# **PRODUCT CHANGE NOTICE**

## **Packing Method Change for Intersil ZLxxxx QFN Packaged Products**

**Refer to:  
PCN11007**

**Date: January 27, 2011**

## Tube Outlines – PCN11007

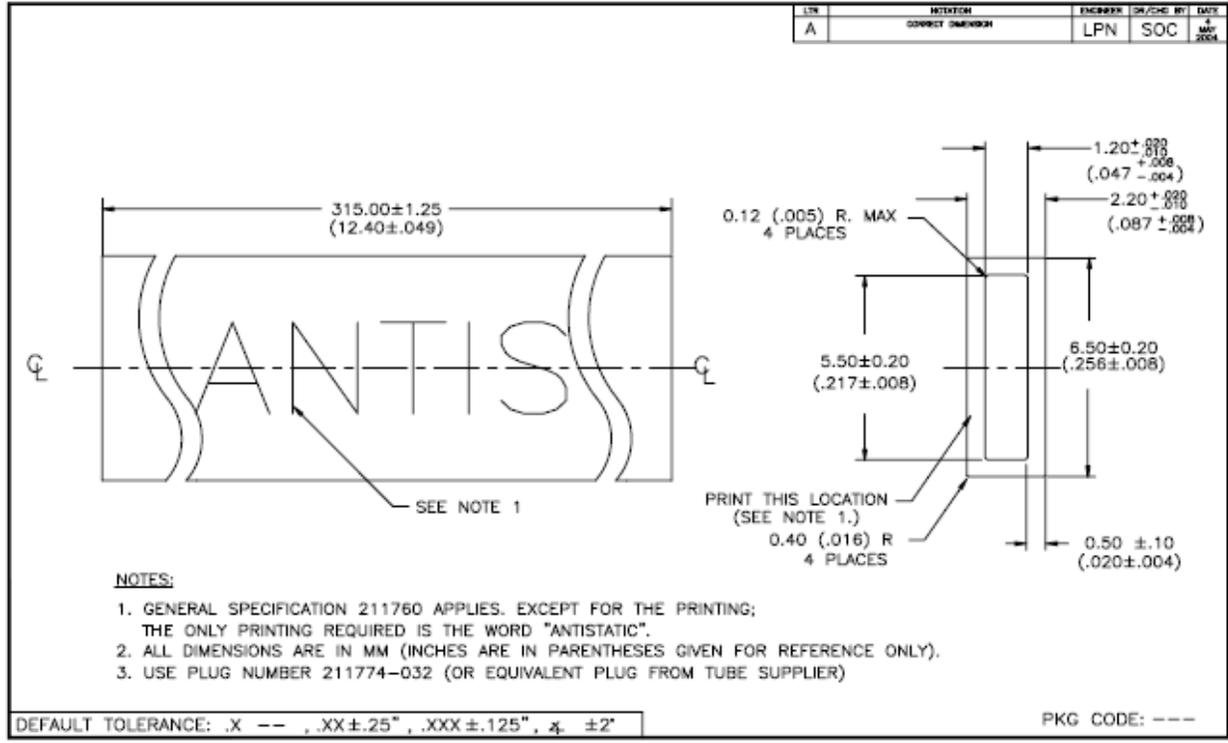
This notice is to inform you that Intersil is changing the packing method for the listed Intersil ZLxxxx QFN (Quad Flat No-lead) packaged products. Intersil will discontinue tray packing and implement packing in anti-static tubes during Q2'2011. The industry standard tubes are made of an anti-static material. Dimensional information and drawings of each type are included for reference. The basic tube information is as follows:

Part Number	Package	Tube Dimensions (millimeter)			Quantity per Tube
		Length	Width	Height	
ZL2004ALNN	32p 5x5 QFN	315	6.5	2.2	60
ZL2004ALNN-01					
ZL2005ALNF	36p 6x6 QFN	315	7.5	2.2	50
ZL2006ALNF					
ZL2105ALNF
